CITY OF NEW YORK  
**MANHATTAN COMMUNITY BOARD FOUR**  
330 West 42<sup>nd</sup> Street, 26<sup>th</sup> floor New York, NY 10036  
tel: 212-736-4536 fax: 212-947-9512  
[www.nyc.gov/mcb4](http://www.nyc.gov/mcb4)

**Re: Streetscape Review for Public Design Commission Streetscape and Safety submission with DOT - Hudson Yards East – 33<sup>rd</sup> Street – 11<sup>th</sup> Avenue**

**HUDSON YARDS PLAZA STREETSCAPE**  
 MANHATTAN COMMUNITY BOARD 4 PRESENTATION RESPONSE

HUDSON YARDS PLAZA STREETSCAPE: AS PRESENTED TO CB ON APRIL 18, 2018

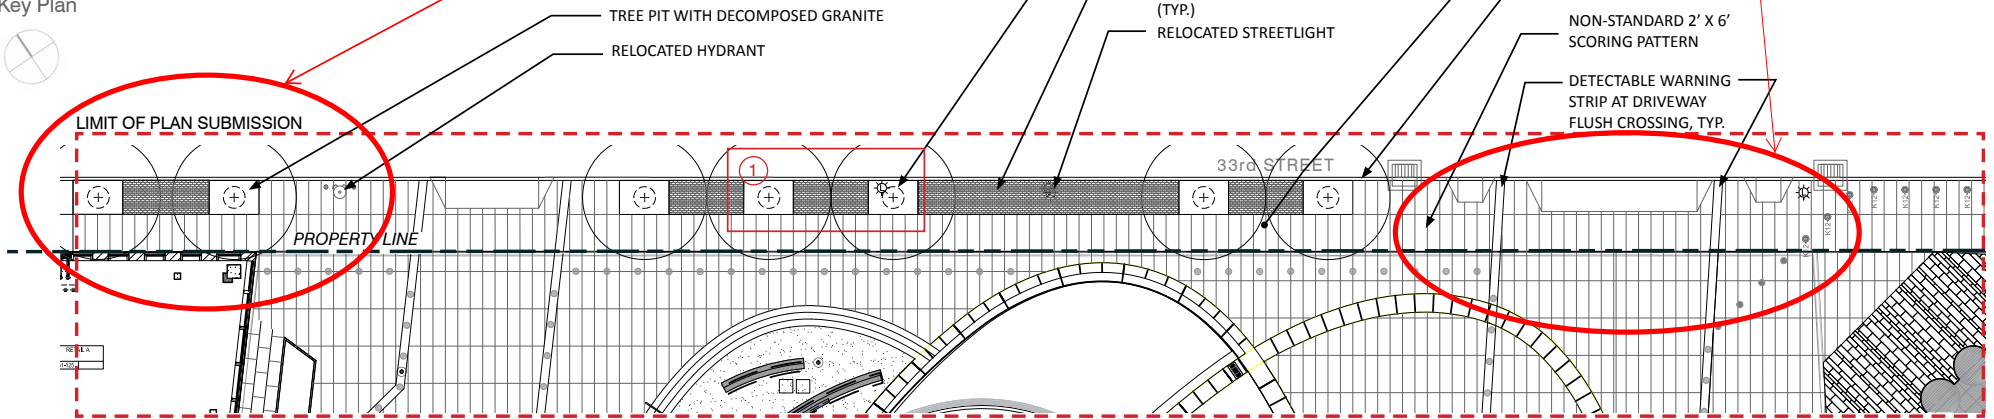
**CB COMMENTS/ FEEDBACK:**  
 - WIDEN SIDEWALK WIDTH BETWEEN BUILDING FACE/ TREE PIT

**CB COMMENTS/ FEEDBACK:**  
 - CONSIDER BULB-OUT  
 - REDUCE DRIVE WIDTH  
 - SHORTEN CROSSING DISTANCES

HUDSON YARDS PLAZA STREETSCAPE: (33RD STREET) OPTION 1A

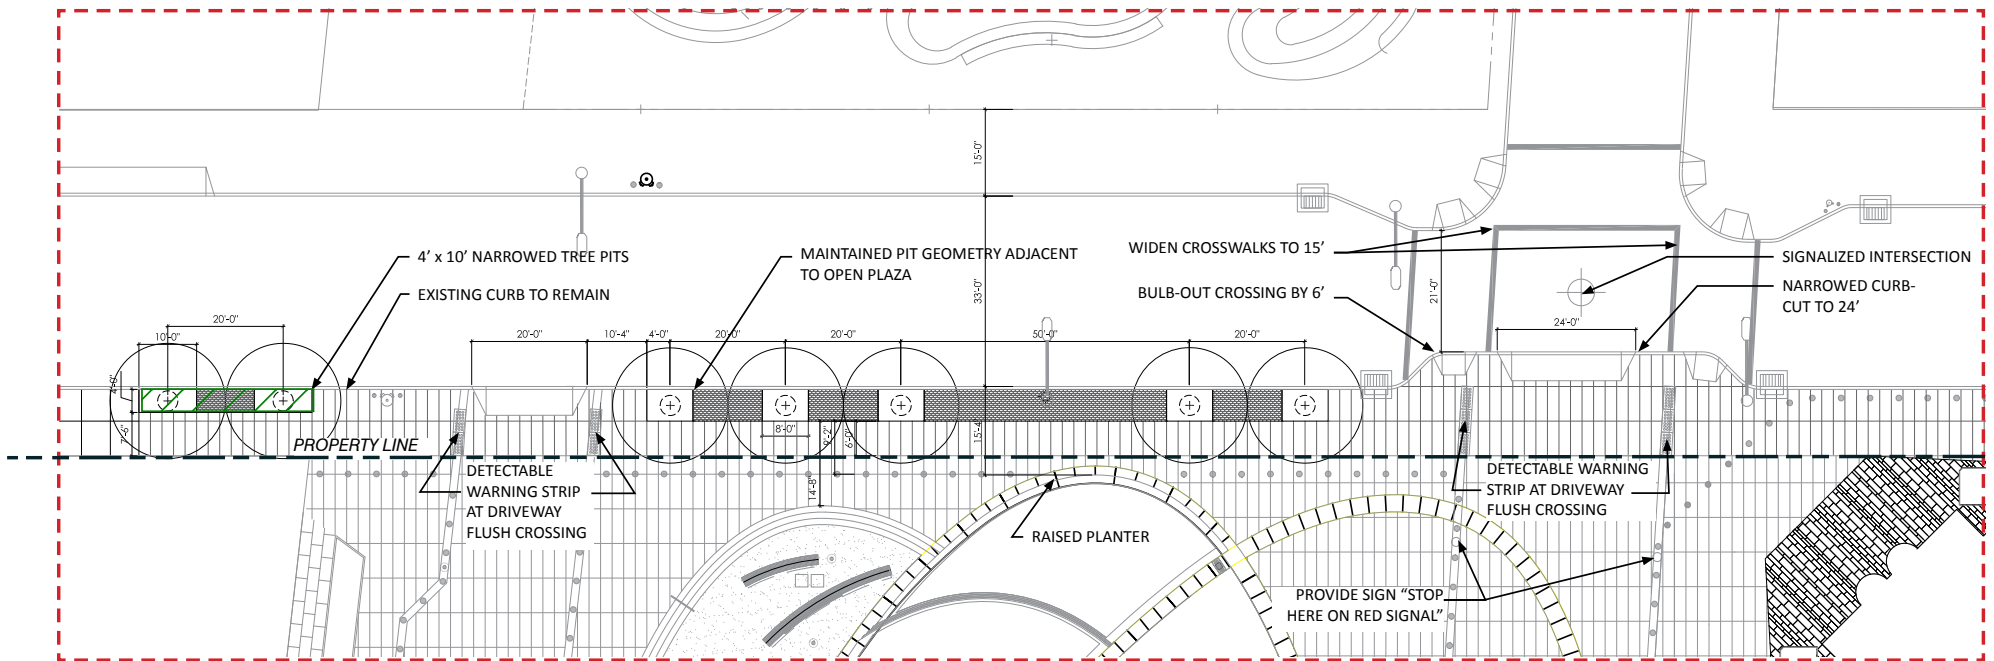
1. Page 1 – Original CB4 Presentation w/ Annotated CB Feedback
2. Page 2 – Proposed Streetscape Adjustments, Option 1A (changes listed in estimated increasing order of coordination/approvals required and timeline to implement).

- A. Addition of signage at the intersection of HB and 33<sup>rd</sup> Street directing cars where to stop when the signal is red. Related can implement this change day 1.

- B. Narrowing of the tree pit detail on 33<sup>rd</sup> Street sidewalk adjacent to 35 Hudson Yards from 5'6" to 4'0". Related can implement this change day 1 subject to Parks' approval of the revised tree pit detail.

- C. Narrowing the curb cut for HB at 33<sup>rd</sup> Street from 30' to 24'. This change is subject to DOB approvals; if approved in a timely manner, Related can implement this change day 1.

- D. Widening the crosswalks at HB and 33<sup>rd</sup> Street from 12' to 15'. The street is currently under DDC control for reconstruction; once complete, the street is turned over to DOT. Related can discuss this change with DOT to gauge interest, and recommend change implementation day 1.

- E. Bulb-outs at the intersection of HB and 33<sup>rd</sup> Street. Any change to the geometry of 33<sup>rd</sup> Street would be subject to a more lengthy coordination and approvals process with DOT. Setting aside whatever DOT's appetite may be to make changes to 33<sup>rd</sup> street immediately following its completion, changes would be subject to coordination with all sub-grade street utilities which has presented problems previously. That said, we remain aligned with CB's interest in enhancing the pedestrian experience in this area, and look forward to further collaboration for a day 2 solution. We will explore alternatives aimed at improving pedestrian safety to the extent a physical bulb-out is not approved.
